802.3ck D1.3

Cable Assembly min IL

Comments #173, #174, #221, and #17

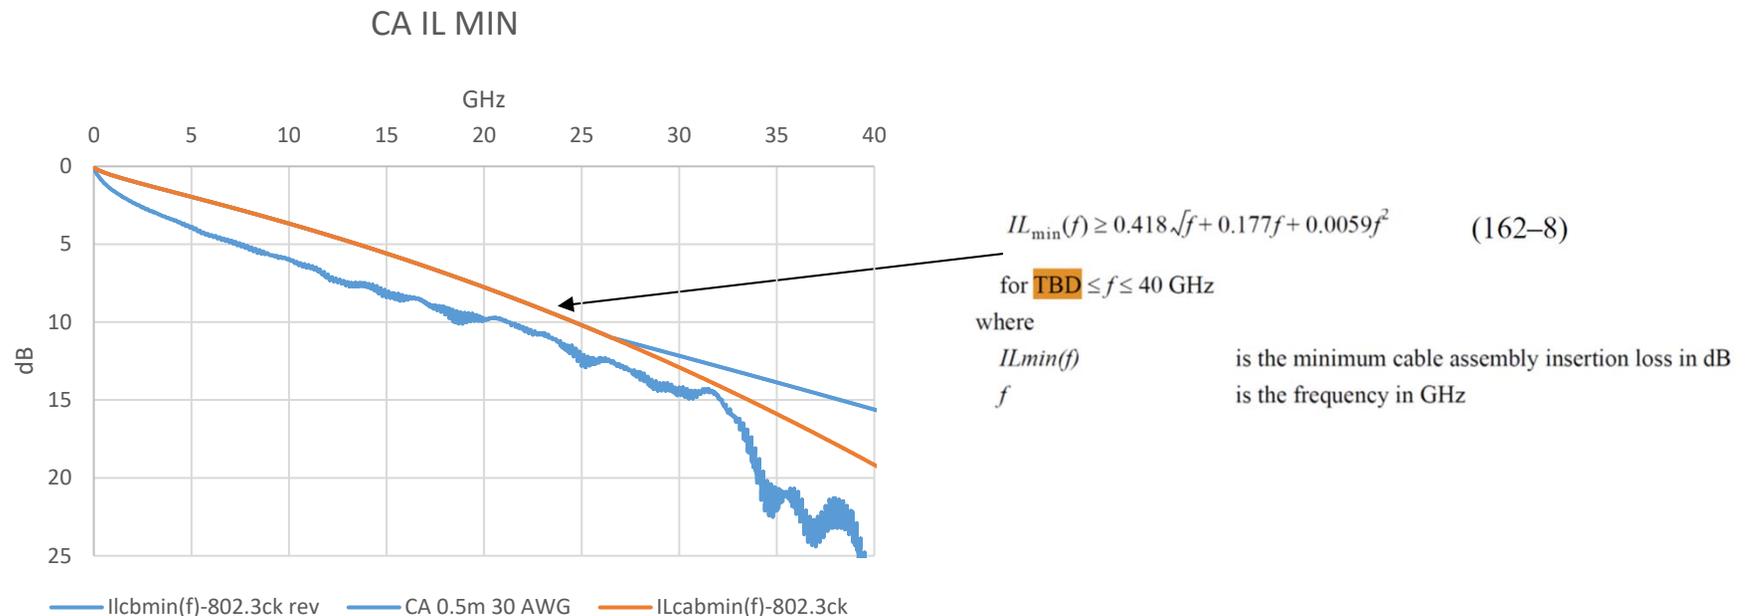
CI 162 SC 162.11.2 P 157 L 8 # 173
Haser, Alex Molex
Comment Type TR Comment Status D CA IL
The minimum IL is too strict to allow 0.5m 30awg cables (see support slide); need to relax min IL limit
SuggestedRemedy
More work needed to determine what the mask should be
Proposed Response Response Status W
PROPOSED REJECT.
The remedy is not sufficiently complete to implement changes to the draft.

CI 162 SC 162.11.2 P 157 L 26 # 221
Dawe, Piers Nvidia
Comment Type TR Comment Status D CA IL
This minimum loss curve bends the wrong way at high frequencies
SuggestedRemedy
Change the limit (Eq 162-10) so it becomes flatter at high frequencies
Proposed Response Response Status W
PROPOSED REJECT.
Resolve using the response to comment #173.

CI 162 SC 162.11.2 P 157 L 10 # 17
DiMinico, Christopher MC Communications
Comment Type TR Comment Status D CA IL
Replace TBD
SuggestedRemedy
Replace TBD with 0.05
Proposed Response Response Status W
PROPOSED ACCEPT IN PRINCIPLE.
[Editor's note: Addresses incomplete specification.]
Implement suggested remedy.

- Comments #173, #221, #17
 - Cable assembly min IL shape, frequency range

$$IL_{min}(f) = 0.418 \cdot \text{SQRT}(f \text{ GHz}) + 0.177 \cdot f \text{ GHz} + 0.0059 \cdot f \text{ GHz}^2 \quad 0.05 \text{ GHz} \leq f \leq 26.56 \text{ GHz}$$

$$IL_{min}(f) = 1.222 \cdot \text{SQRT}(f \text{ GHz}) + 0.138 \cdot f \text{ GHz} + 0.0015 \cdot f \text{ GHz}^2 \quad 26.56 \text{ GHz} < f \leq 40 \text{ GHz}$$
